SITE NAME: **CSP BARRETT**  
 PROJECT ID: 17072981  
 PROJECT: MW UPGRADE  
 SITE ADDRESS: 15741 PHANTOM CANYON VIEW  
 COLORADO SPRINGS, CO 80926  
 COUNTY: EL PASO  
 JURISDICTION: EL PASO COUNTY

MW UPGRADE  
 (EXISTING COMMUNICATIONS SITE)

SHEET TITLE  
 TITLE SHEET

SHEET NUMBER  
 T-1

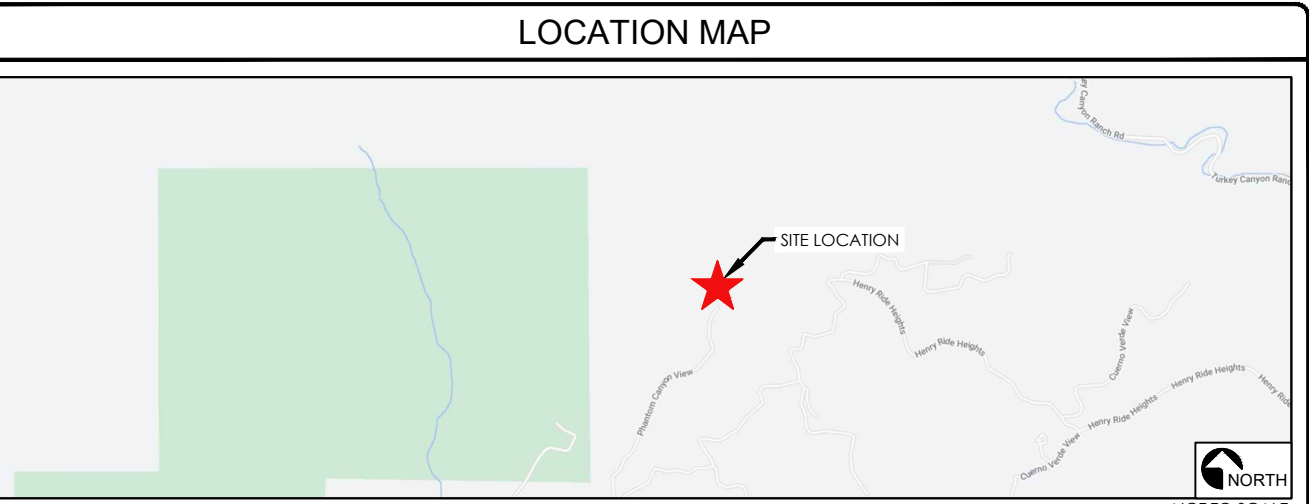
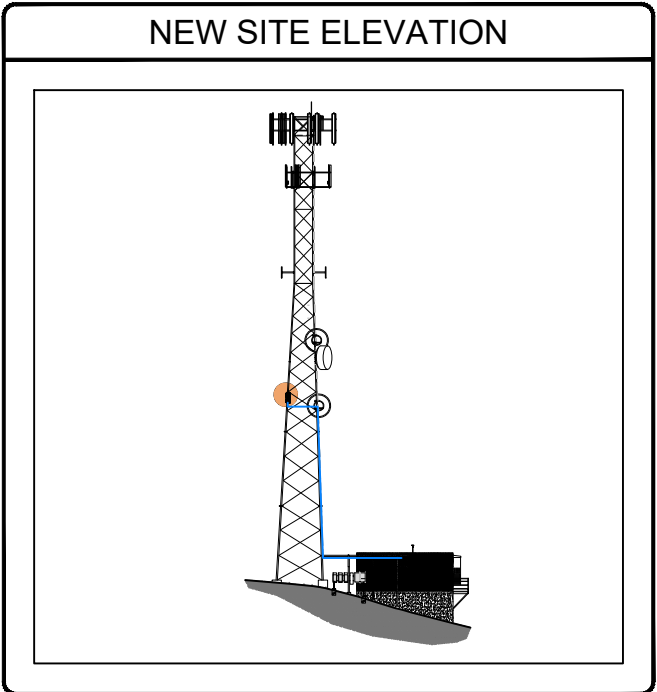
**Add:**  
 - Legal description  
 - Lot/parcel size  
 - Signature block for Planning and Community Development approval a minimum of 1 inch by 2 inches
